Model: Kaiser1 Date: 16-Mar-00 No.: MH306001a

MB Correction

Modified Article: Parts Catalog Corrections				Prepared by: M. Mano		
From: Technical Ser	rvice Dept., GTS Division					
Reason for	□ Parts catalog correction	☐ Vendor ch	ange	☐ To meet standards		
Modification: ☐ To facilitate assembly ☐ To improve re		e reliability	()			
	☐ Part standardization	☐ Other

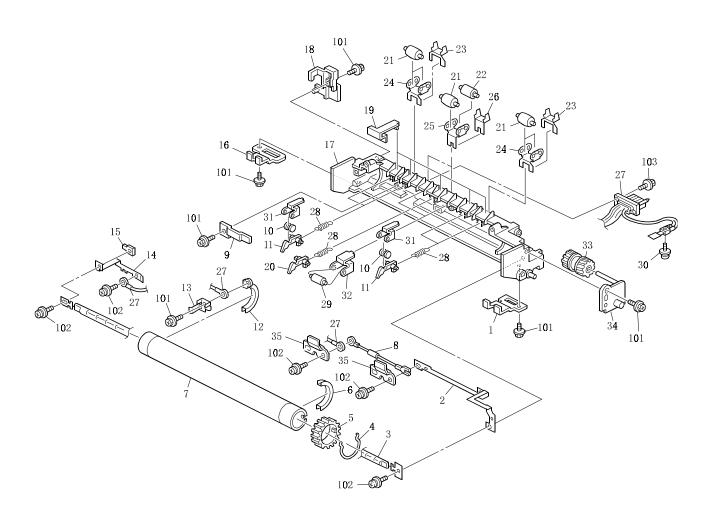
Old part	New part	Description	Q'ty	Int	Page	Index	Note
number	number						
G0294161	H3065068	Thermofuse – 169°C	1	X/O	35	8	
-	G0294133	Cover Screw	2		35	35	*2

- *1: These parts have been used since the first mass production lot.
- *2: This part was not included in the original illustration (not a new part). Please add the index description and illustration.

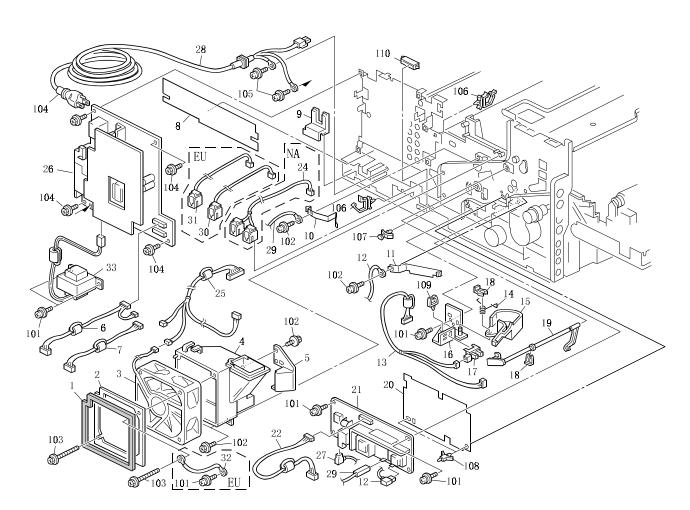
Old part	New part	Description	Q'ty	Int	Page	Index	Note
number	number						
H3065010	H3065011	PSU	1	X/O	41	26	
H3065207	H3065223	Harness NCU-6P	1	X/O	41	30	
H3065212	H3065224	Harness NCU-4P	1	X/O	41	31	
-	N6074525	Choke Coil RITL-9704	1		41	33	*2

- *1: These parts have been used since the first mass production lot.
- *2: This part was not included in the original illustration (not a new part). Please add the index description and illustration.

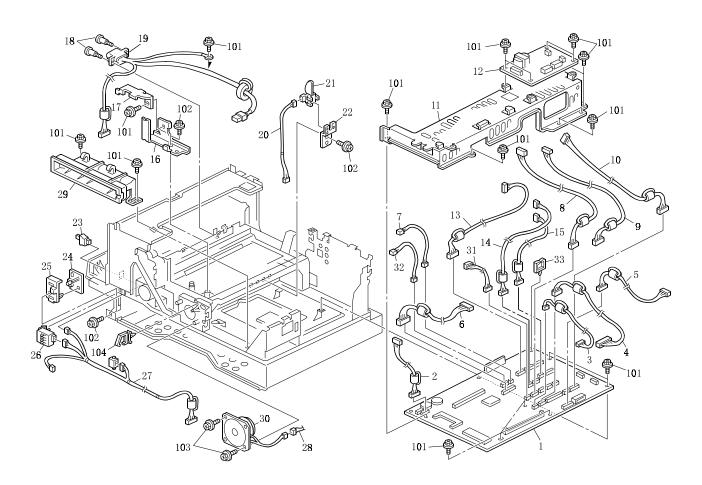
Old part number	New part number	Description	Q'ty	Int	Page	Index	Note
-	H3063198	Clamp	1		43	33	*1

^{*1:} This part was not included in the original illustration (not a new part). Please add the index description and illustration.

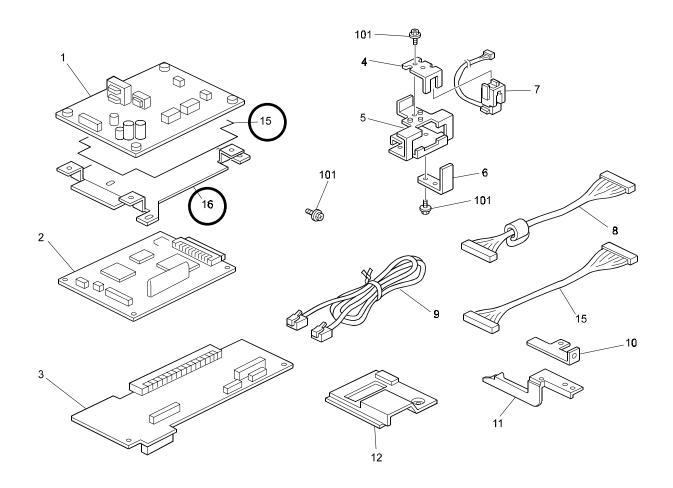
Old part number	New part number	Description	Q'ty	Int	Page	Index	Note
-	54886141	NCU Board – EU/Asia	1		3	1	*1
-	H3064648	Insulation Sheet	1		3	15	*2
	H3064634	Bracket – NCU	1		3	16	*2

Please add in the three index descriptions above along with the illustration for the Insulation Sheet and the NCU Bracket (#15 and 16, circled below).

^{*2:} These parts were not included in the original illustration (not new parts).

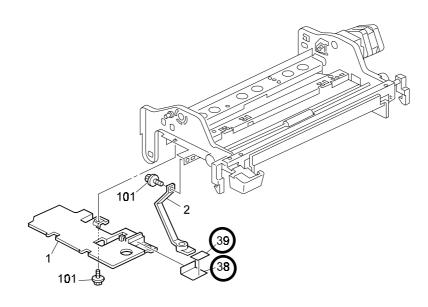
Old part	New part	Description	Q'ty	Int	Page	Index	Note
number	number						
-	H3061334	Sheet ADF Switch 1	1		13	38	*1
-	H3061335	Sheet ADF Switch 2	1		13	39	*1

Please add in the two index descriptions above along with the illustration for the Sheet ADF Switch 1 and Sheet ADF Switch 2 (#38 and 39, circled below).

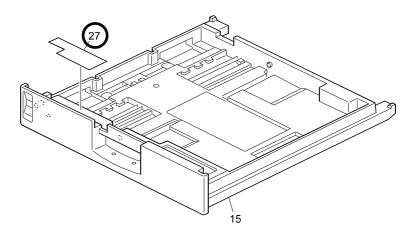
Old part	New part	Description	Q'ty	Int	Page	Index	Note
number	number						
H5235003	AW020075	Photointerrupter	1	X/O	21	5	*1
H3063183	H3062099	Decal – Fusing Cover1	1	O/O	27	7	*2
G0293863	G0293967	Discharge Brush	1	X/O	27	18	*3
H3063129	H3063151	FCU Shield Cover	1	X/O	43	11	*4
G0294175	H3062137	Stripper Pawls	1	O/O	35	20	*2
H3063334	H3063197	Adjusting Screw	1	X/O	45	26	*5
	H3063335	Decal Paper Size	1		29	27	*6

- *1: The old part number was misprinted.
- *2: The new part will be used after the old part is out of stock.
- *3: For the USA, the new part will be used after the old part is out of stock. For Europe/Asia, the new part will be used from the first mass production lot.
- *4: For the USA, the new part has been used since April mass production lot. For Europe/Asia, the new part will be used from the first mass production lot.
- *5: For the USA, the new part has been used since the February mass production lot. For Europe/Asia, the new part will be used from the first mass production lot.
- *6: The new part has been added since the June mass production lot. (see the following illustration)

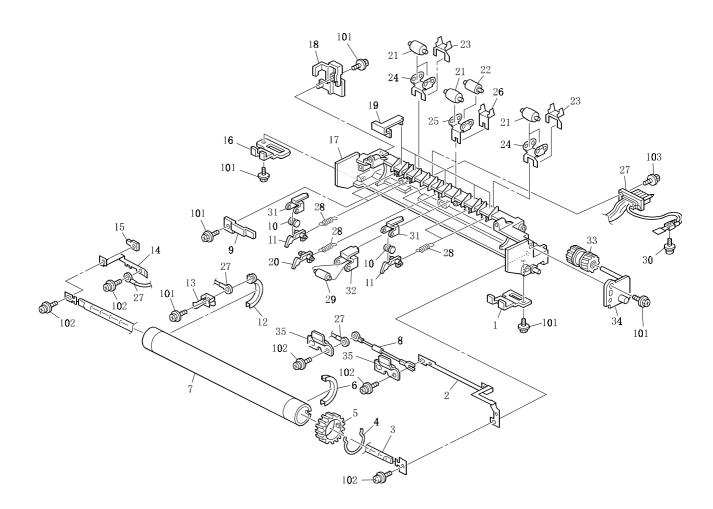
It is possible for the fusing harness cover to become warped due to heat (rare occurrence). To prevent this, its composition has been changed from plastic to metal. Please make the following corrections to your Parts Catalogs.

Old part number	New part number	Description	Q'ty	Int	Page	Index	Note
Ì	G0294138	H3062179	Fusing Harness Cover	1	X/O	34	9
